Gas Assist Thrust Washer Replacement

Models Covered	Serial Number Or Year
60 HP EFI FourStroke	1C139538–1C207842
75 SeaPro	1B828336–1B913257

Please contact your Mercury Outboard dealer and mention Service Bulletin 2013-05 to schedule an appointment to have this inspection performed on your outboard. Your dealer will be able to determine how long this inspection/correction will take.

a - Damage to the camshaft and camshaft retainer plate

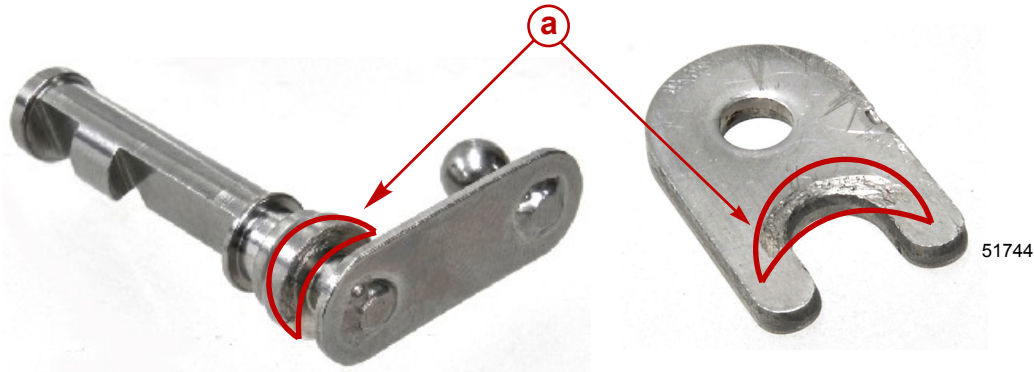
6. Inspect the camshaft and camshaft retainer plate for signs of damage. If damage is present, replace the camshaft assembly. If no damage is found, proceed with thrust washer and spacer replacement. (Camshaft removed from manifold for clarity purpose only. Do not remove unless damage is evident).

NOTE: If using a camshaft assembly kit from your stock, ensure that the kit contains a black spacer. If the kit contains a white spacer, both the spacer and thrust washer should be discarded. The correct thrust washer will have a dark gray shiny appearance.

- a -** Gas assist camshaft
- b -** Thrust washer
- c -** Gas assist camshaft shoulder (area 2-4-C with PTFE needs to be applied to)

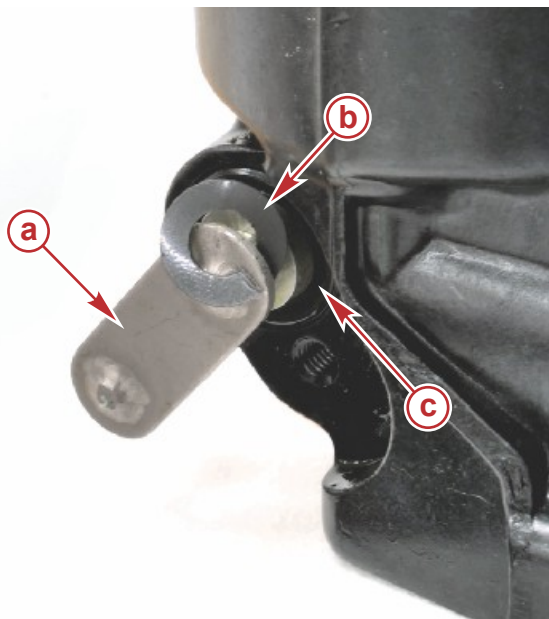
7. Install the replacement thrust washer on the camshaft. Using the slit in the thrust washer, spin the thrust washer onto the gas assist camshaft. Once the thrust washer is installed, apply 2-4-C with PTFE to the shoulder of the gas assist camshaft.

- a - Camshaft retainer screw
- b - Spacer
- c - Camshaft retainer plate

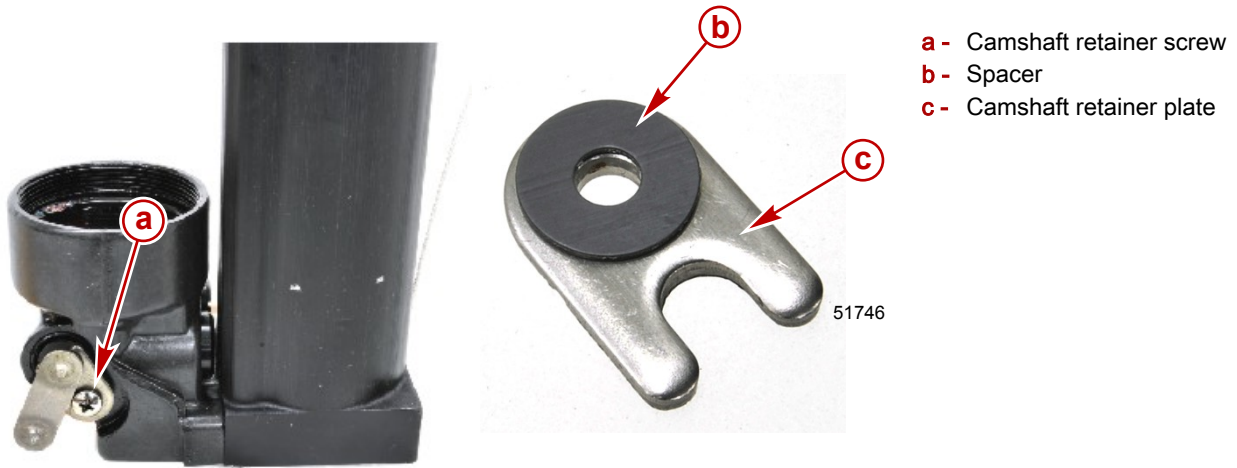
8. Install the camshaft retainer plate and spacer. Torque the screw to specification.

Description	Nm	lb-in.	lb-ft
Retainer plate screw	3.6	32	-
